Crystal River Nuclear Plant
Docket No. 50-302
Operating License No. DPR-72

July 24, 2002
3F0702-01

Subject: Crystal River Unit 3 – Supplemental Information Regarding the 15-Day Response to NRC Bulletin 2002-01, "Reactor Pressure Vessel Head Degradation and Reactor Coolant Pressure Boundary Integrity"

NRC Question and FPC Response

**Pictures Taken During Refuel Outage 12,
After the RPVH Cleaning,
While the Water Had Not Yet Dried on the RPVH**

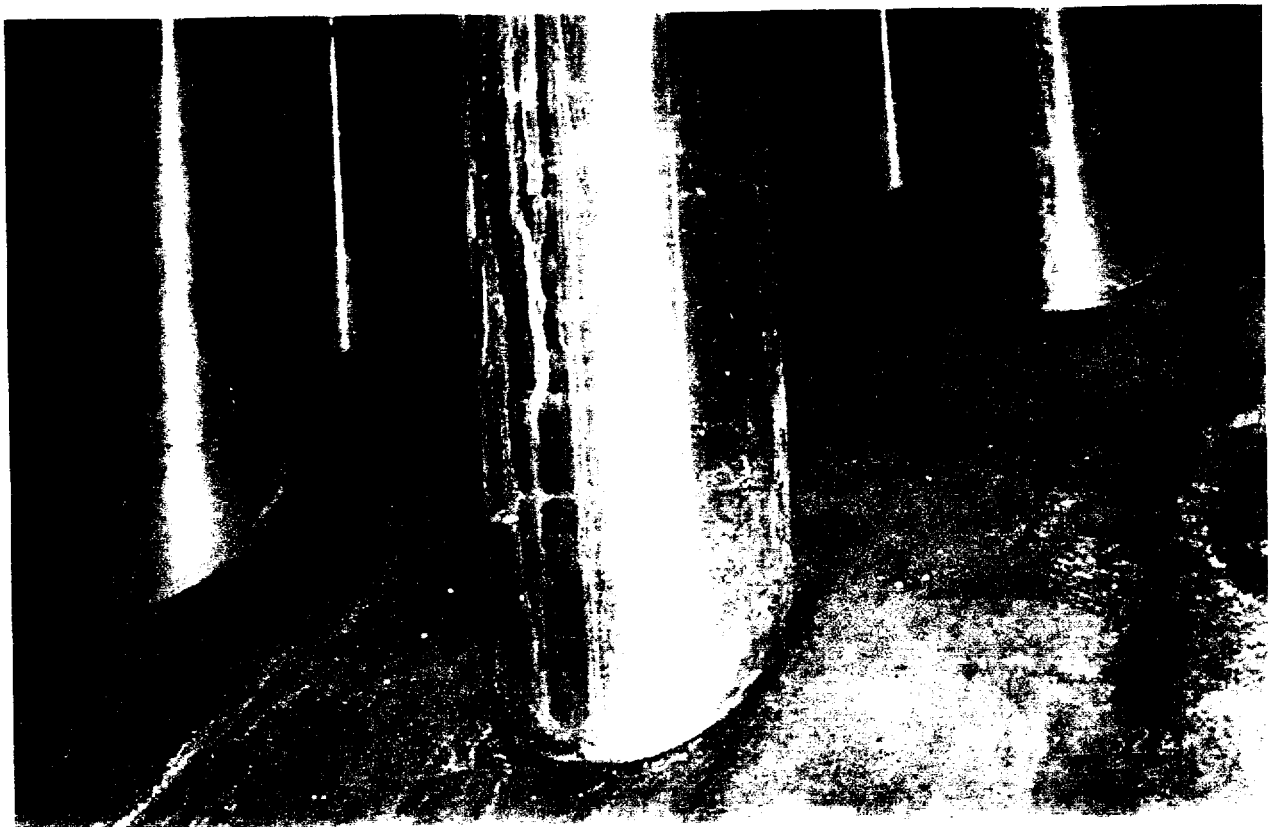
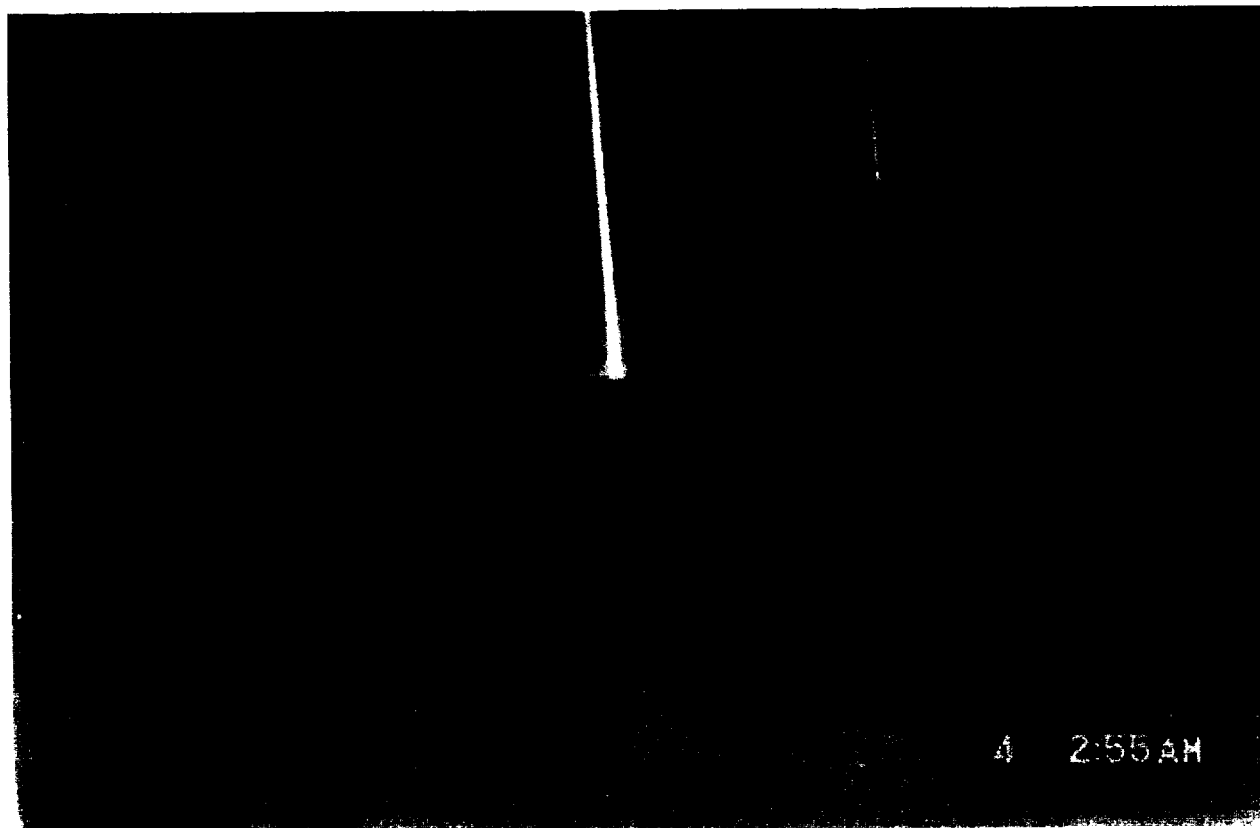
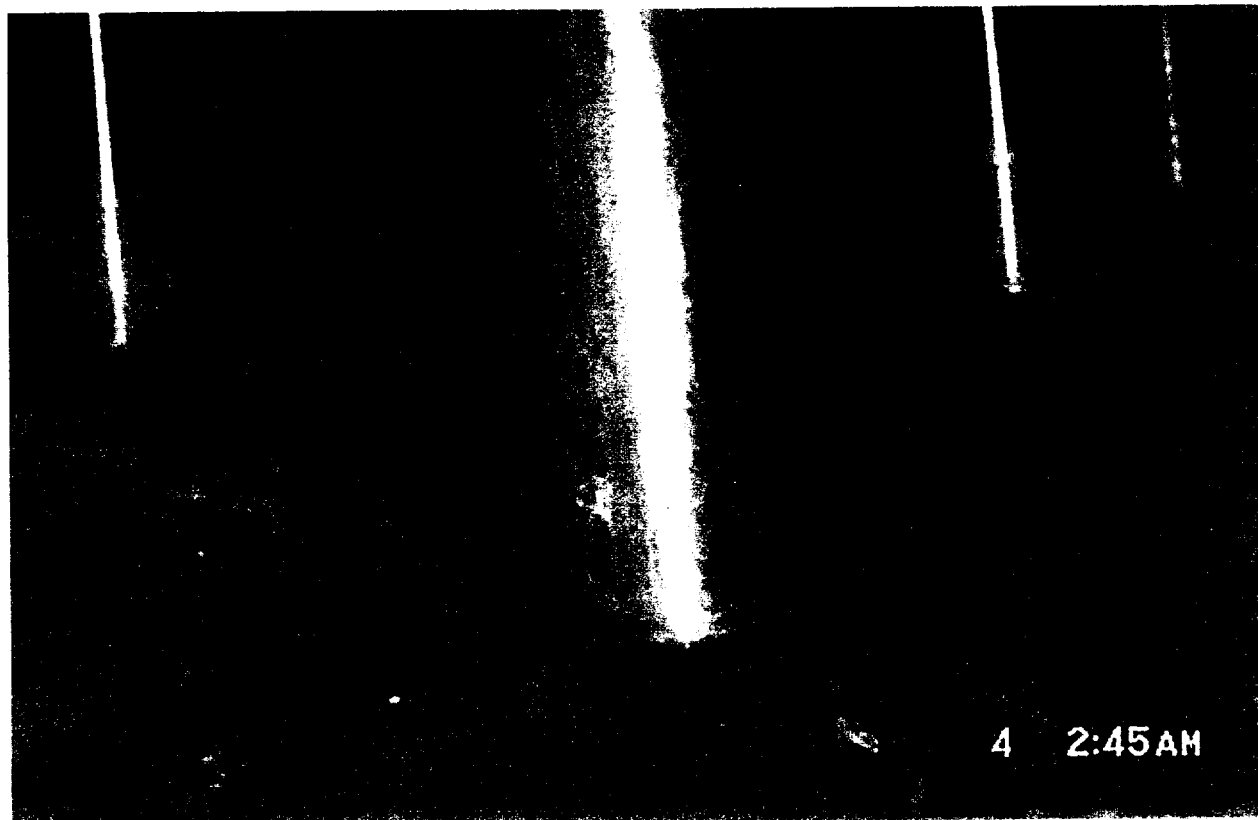
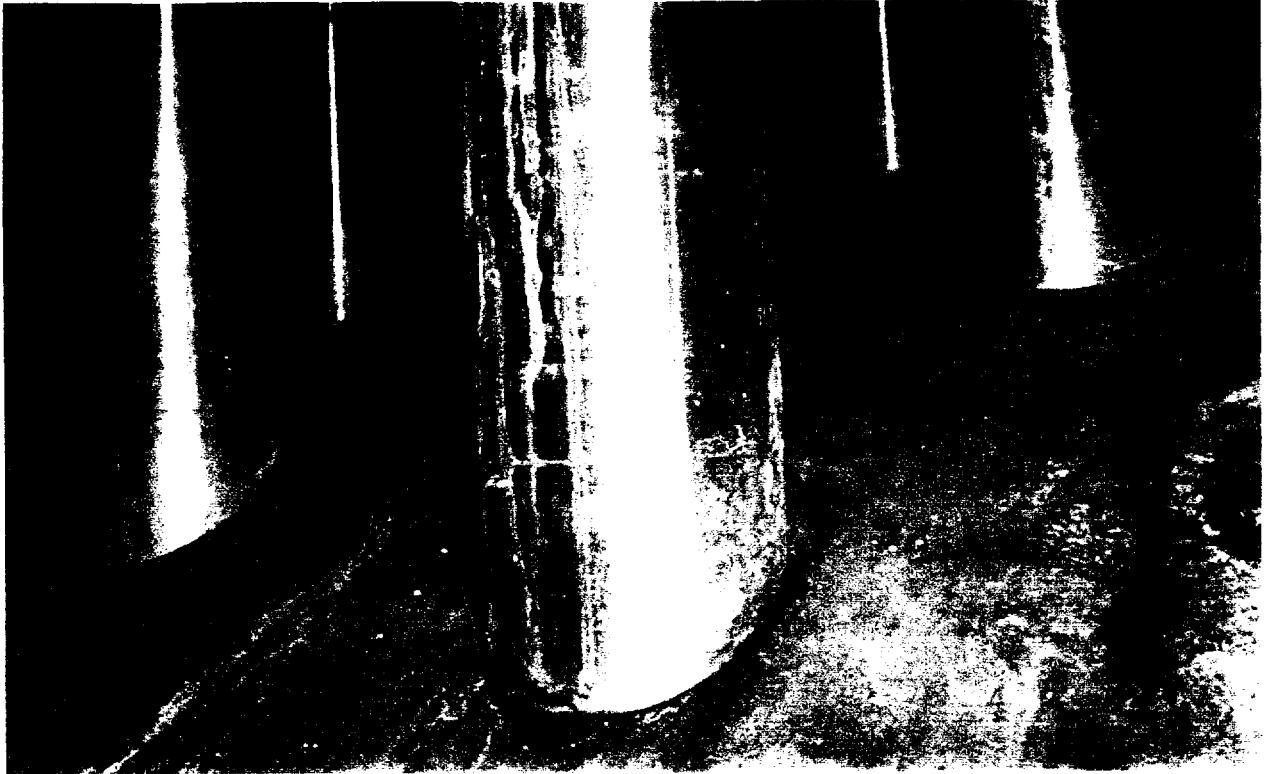
Your 15-day response to Bulletin 2002-01 states that you cleaned the reactor pressure vessel (RPV) head in 2001. Following the cleaning of the RPV head, were any significant deposits left on the head (i.e., deposits that prevent seeing the bare metal of the head for an area greater than 1 square inch).

The Inservice Inspection (ISI) group performed the as-found RPV head inspection and subsequent head inspection after cleaning during the Fall 2001 refueling outage. The entire RPV head was visually examined. These examinations revealed evidence of boron on the RPV head. One leaking Control Rod Drive nozzle was found and repaired. Other boric acid deposits were determined to be from previous flange leakage. The deposits were cleaned with water and another visual inspection was performed. A slight sheen was left on the RPV head in some areas, but the bare metal of the RPV head was still visible. This sheen was due to old boric acid residue being left on the head after the water had dried following cleaning. Attachment B contains pictures that were taken immediately after the RPV cleaning. These pictures show some shine caused by water that had not yet dried on the RPV head. Attachment C provides additional pictures that were taken after the RPV head was totally dry.

The visual inspection performed after cleaning the RPV head revealed that there were no significant deposits left on the head.
